ACCESSION NBR: 8310120097 DOC. DATE: 83/10/05 NOTARIZED: NO DOCKET #
 FACIL: 50-220 Nine Mile Point Nuclear Station, Unit 1, Niagara Powe 05000220
 AUTH. NAME AUTHOR AFFILIATION
 MANGAN, C.V. Niagara Mohawk Power Corp.
 RECIP. NAME RECIPIENT AFFILIATION
 VASSALLO, D.B. Operating Reactors Branch 2

SUBJECT: Forwards response to 830908 request for addl info re critically analysis, supporting application for amend spent fuel storage capacity expansion.

RESPONSE TO QUESTIONS ON NINE MILE POINT UNIT 1
SPENT FUEL STORAGE CAPACITY EXPANSION

Figure 1

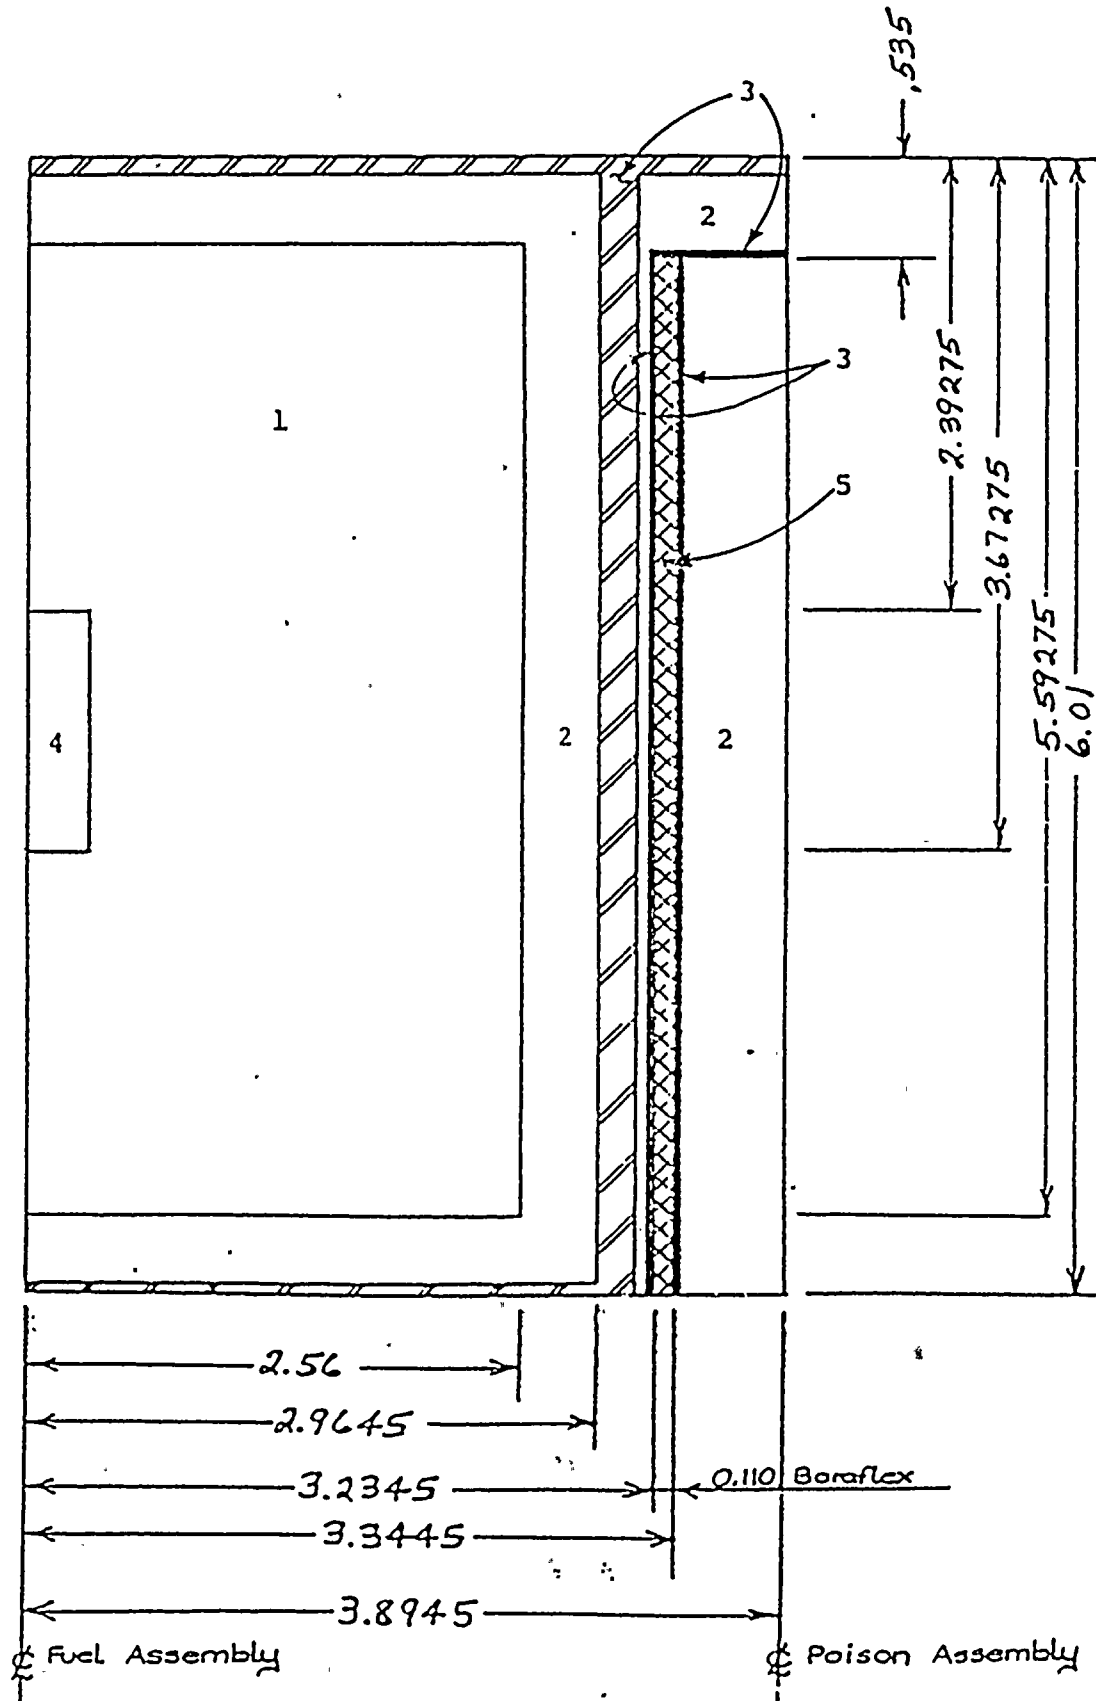
Provide information on a) K_{∞} calculations, b) computer code benchmarking.

- a. See attached Table 1, Summary of Perturbations to the Multiplication Factor of the Basic Cell and Figure 1, Basic Rack Cell Geometry and Dimensions for the Minimum Pitch Between Bundles.
- b. The criticality safety analysis model consists of a proprietary version of the LEOPARD computer program (for generating four energy group neutron cross sections) and the PDQ-7 computer program (for calculating the neutron multiplication factor of the specific geometry and materials comprising the spent fuel storage racks). The resulting analysis model has been extensively benchmarked against the reliable and applicable critical experiments to determine both the bias and uncertainty in the analysis model.
